# CHANGE ORDER

Project Name: **Haverhill Consentino Middle School** CO No. **17**

Architect's Project No. **21-0818**

Subject: **Community Room PR-72** PCO Issue Date: **2025.11.12**  
 PCO Reviewed: **2025.11.14**

C4.01

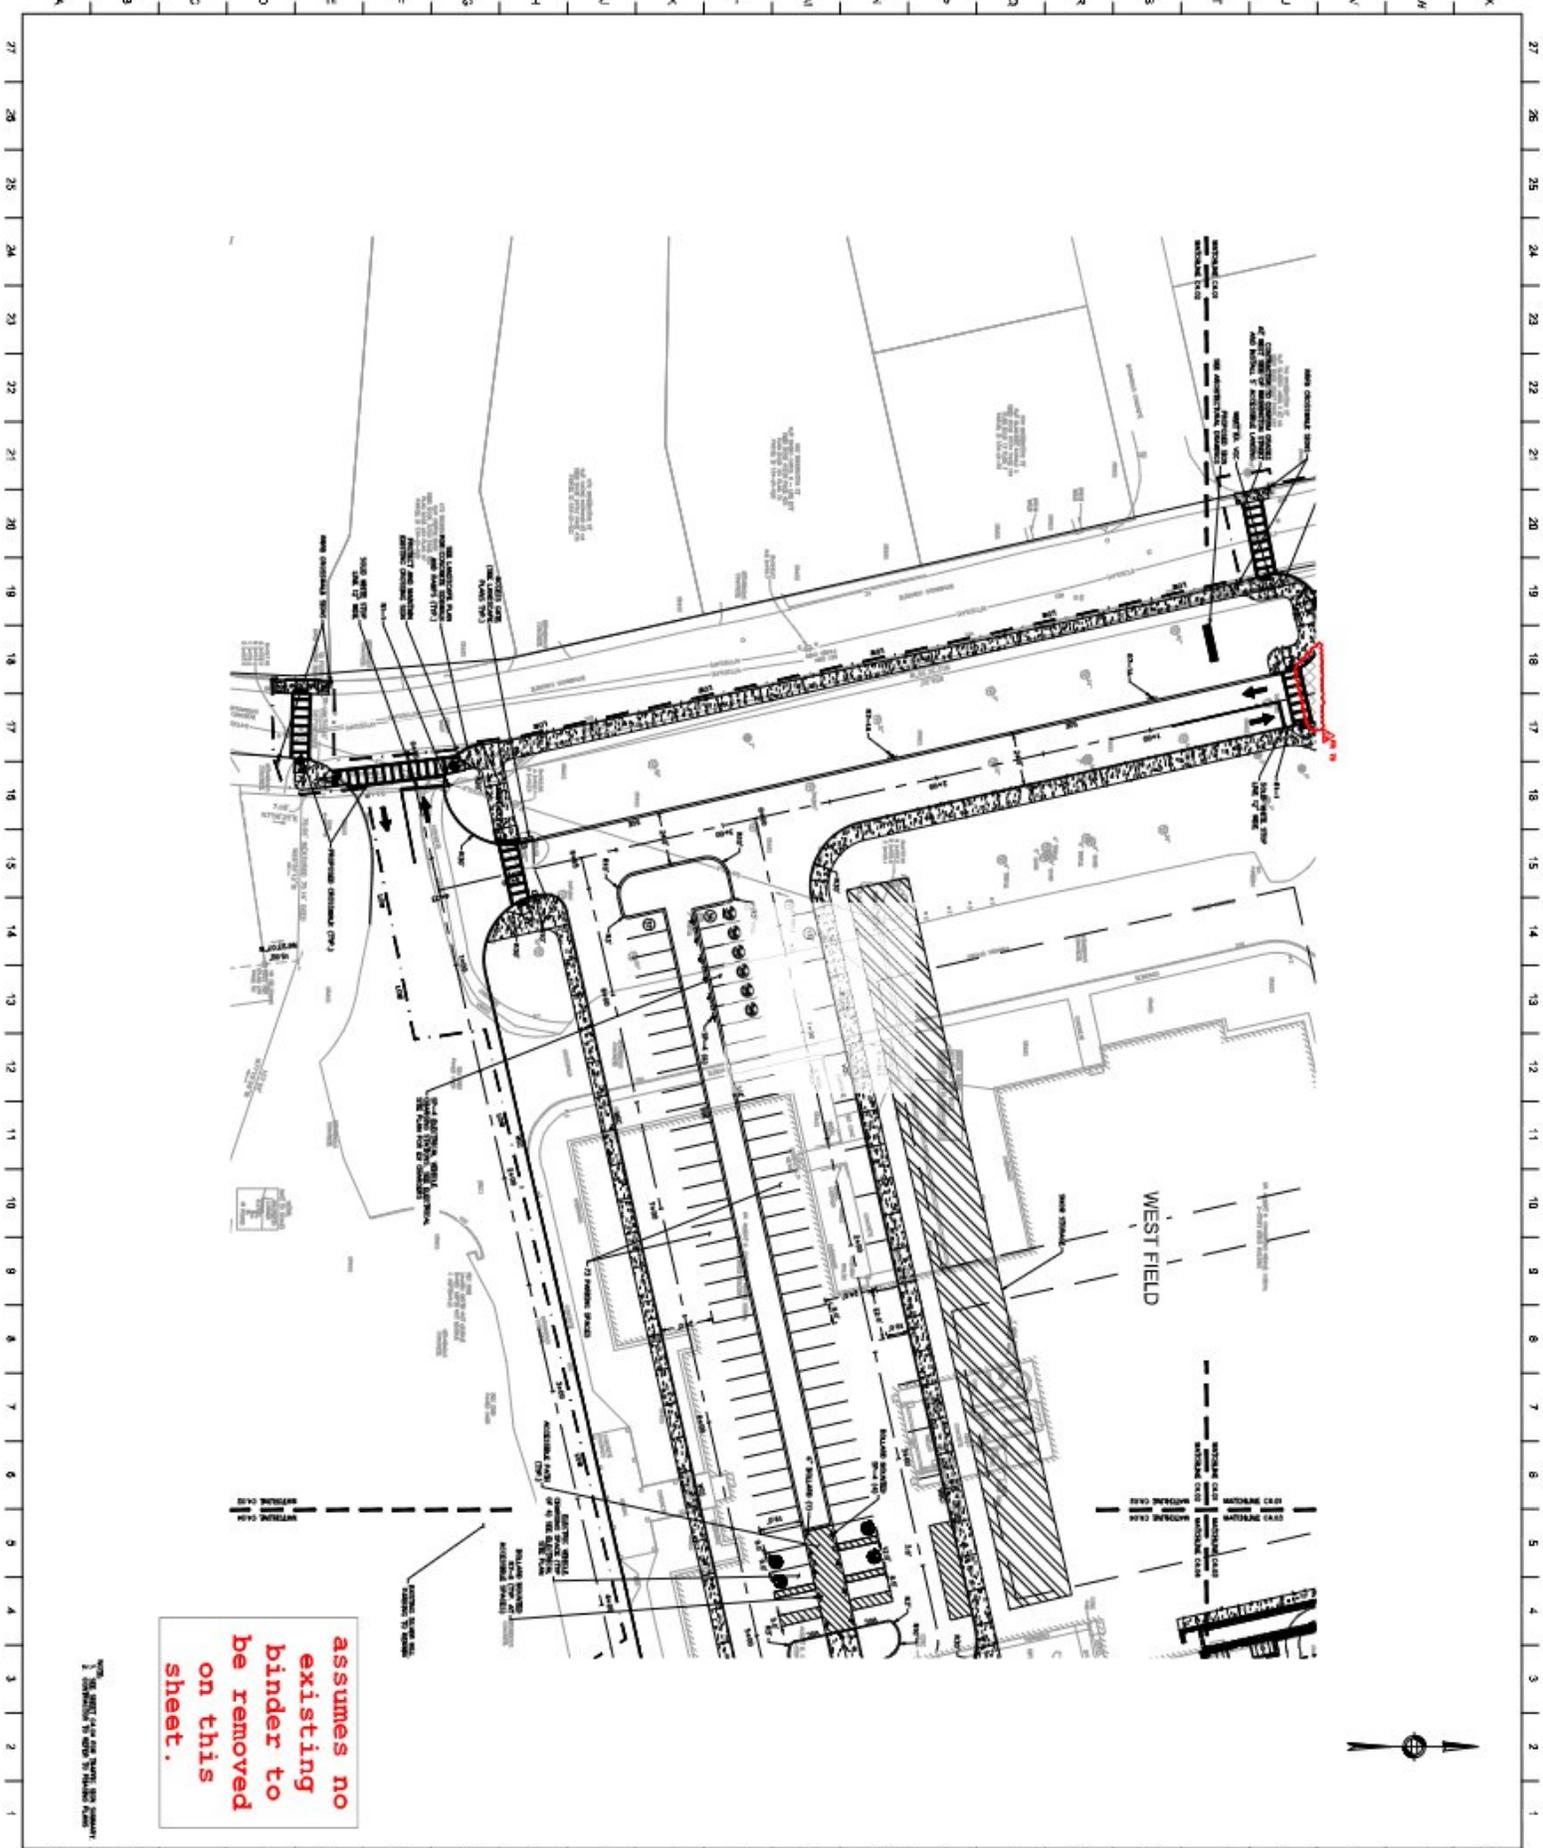
At Sheets C4.01 C4.02, C4.03, C4.04, LAYOUT PLANS, see limits of geotextile shown on attached.

REFERENCE DOCUMENT(S): \_\_\_\_\_  
DRAWING NO.(S) P1.03, P1.13  
SPECIFICATIONS: \_\_\_\_\_  
OTHER \_\_\_\_\_

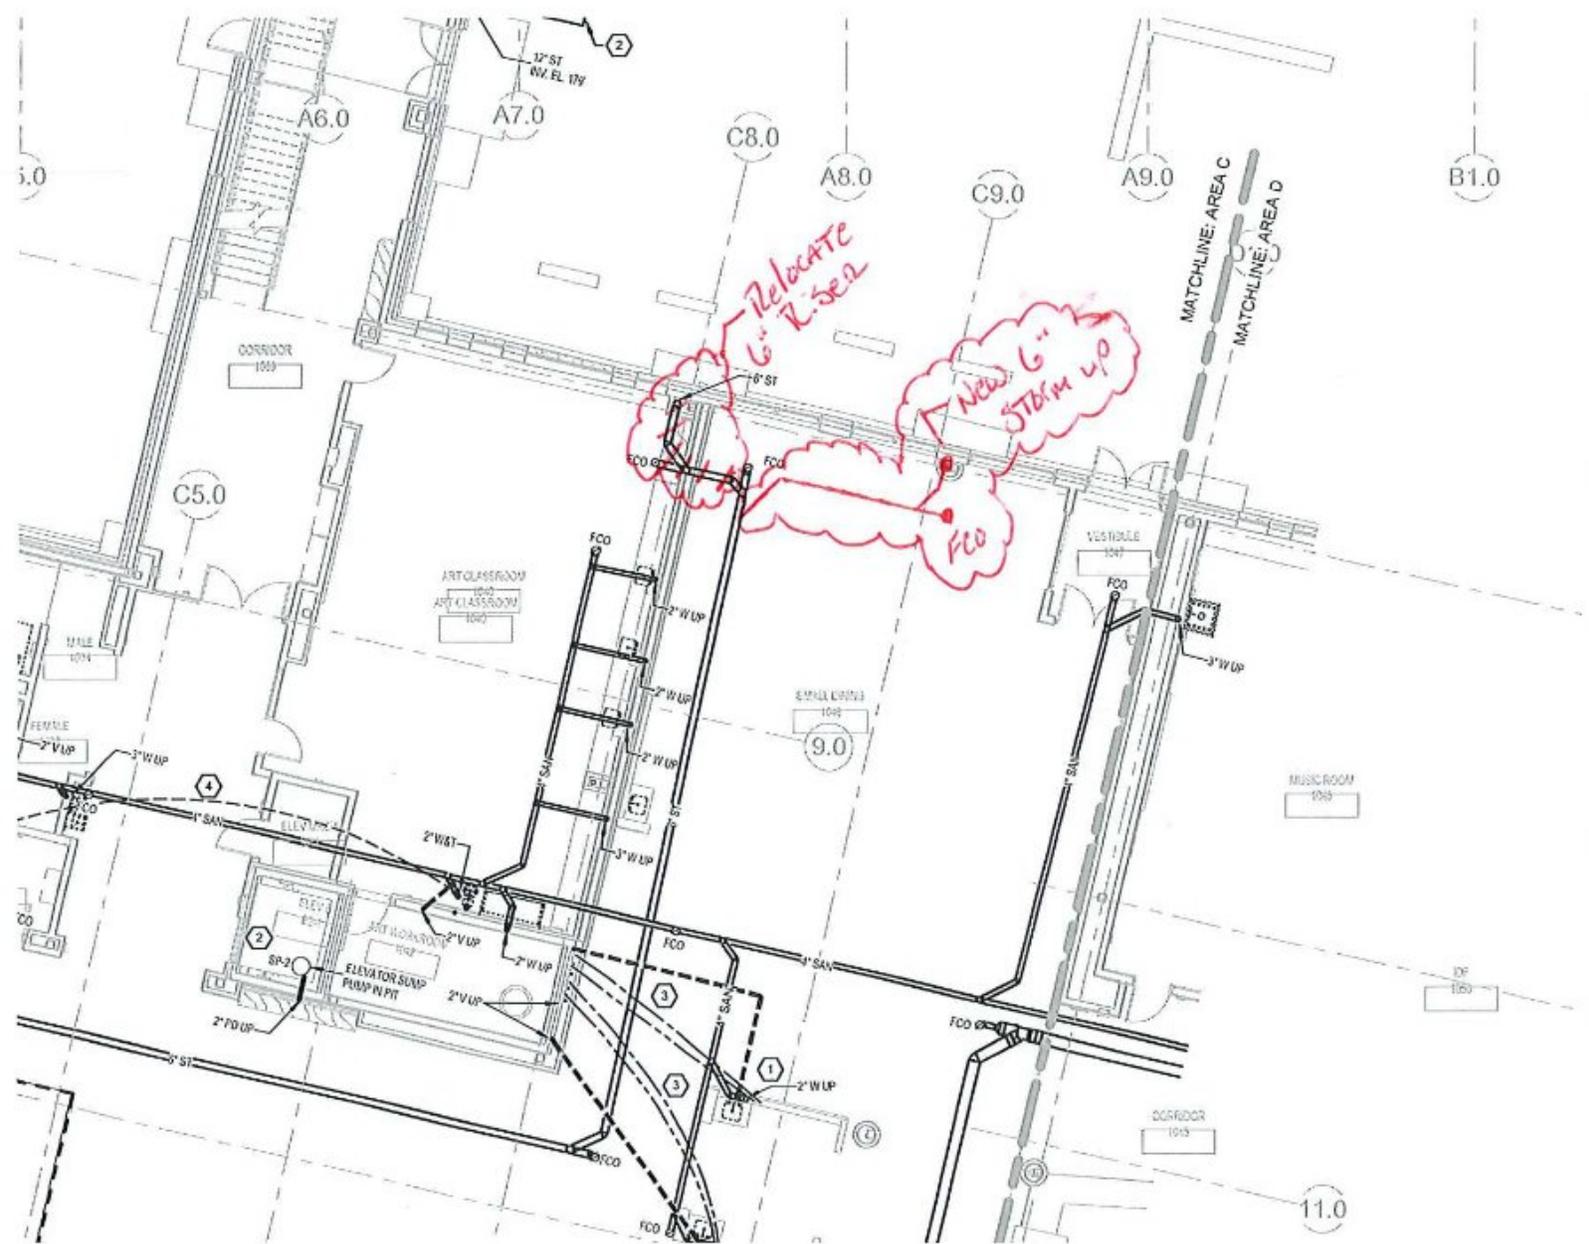
INFORMATION NEEDED: Please review attached snapshots and advise on suggested routing to alleviate coordination conflicts:

1. Relocate 6" storm riser on column line C.8 & 8.0 to column chase on C.9 & 8.0.
2. Delete DSN and piping on column line C.8 & 8.0 and tie into overflow and DSN on column line D.0 & 8.0. Is 6" large enough or should pipe be enlarged?
